Request For Deviation / Waiver

Dev # - DAS-D09Date January 23, 2001Deviation ☒ Waiver ☐

Name: ITT Industries, Inc		Address: ITT Industries, Inc. 1761 Business Center Drive Reston, VA 20190	
Title Of Deviation / Waiver: DAS Electronic Equipment Rack Deviation			
Contract Number: GS-35-01095, Order # S 87070-Y, Task 11		Cage Code: 9M715	
Classification:		Minor <input checked="" type="checkbox"/>	Major <input type="checkbox"/> Critical <input type="checkbox"/>
Part Number: 012-600030-01	Title: Electronic Equipment Enclosure		
Effectivity: Serial Number(s): 001 thru 012		Recurring Deviation/ Waiver: Yes <input type="checkbox"/> No <input checked="" type="checkbox"/>	
Effect on Cost: NONE		Effect on Schedule: NONE	
Effect on Logistics Support, Interface or Software:		NONE	
Reference Documents: STDN 270.5, SRD#			
Description of Deviation / Waiver: (see figure 1) The vertical wire mold will be modified so that it will provide 24 ac outlets over its 6-foot length. The rear rail design is changed to reflect notching a portion of rail out to allow for clearance with the doghouse. No power inlet box will be installed, but instead, the cord from the wire mold will connect with the doghouse

Figure 1: Lateral view of rack with modifications

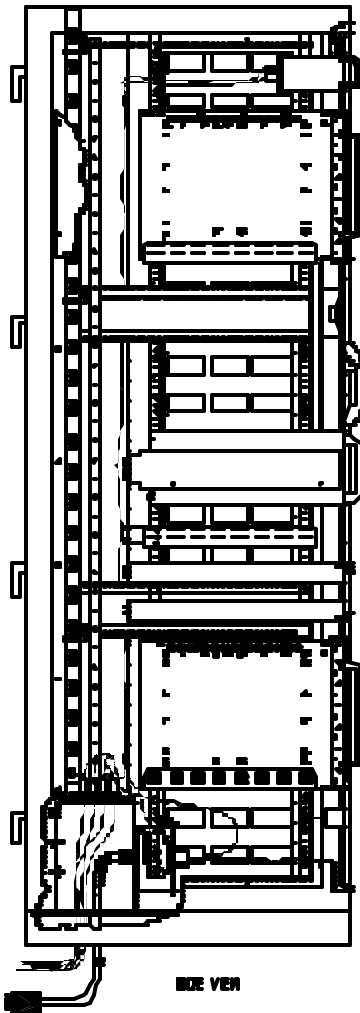
Need for Deviation / Waiver: Modification 1 – Insufficient power sockets in wire mold; need additional sockets for rack equipment Modification 2 – Insufficient clearance between doghouse and wire mold called out in 270.5 Modification 3 – Portion of rear rail interferes with doghouse Modification 4 – Power inlet box on side of rack will be eliminated, and the doghouse power box will be used in its place Modification 5 – Due to elimination of inlet box, the wire mold will be modified to plug directly into the doghouse power box			
Corrective action taken: Modification 1 – Use a wire mold with 24 ac outlets on a 6-foot length (no longer 6" separation between outlets) Modification 2 – Use a shorter wire mold than called out in 270.5 to allow for clearance from doghouse Modification 2 – Modify bottom of rear rail to provide clearance Modification 3 – Connect power cord from wire mold directly to doghouse power box instead of power inlet box Modification 4 – Convert from 3-prong to 3-wire twist lock plug; modify power supply cord-plug on wire mold
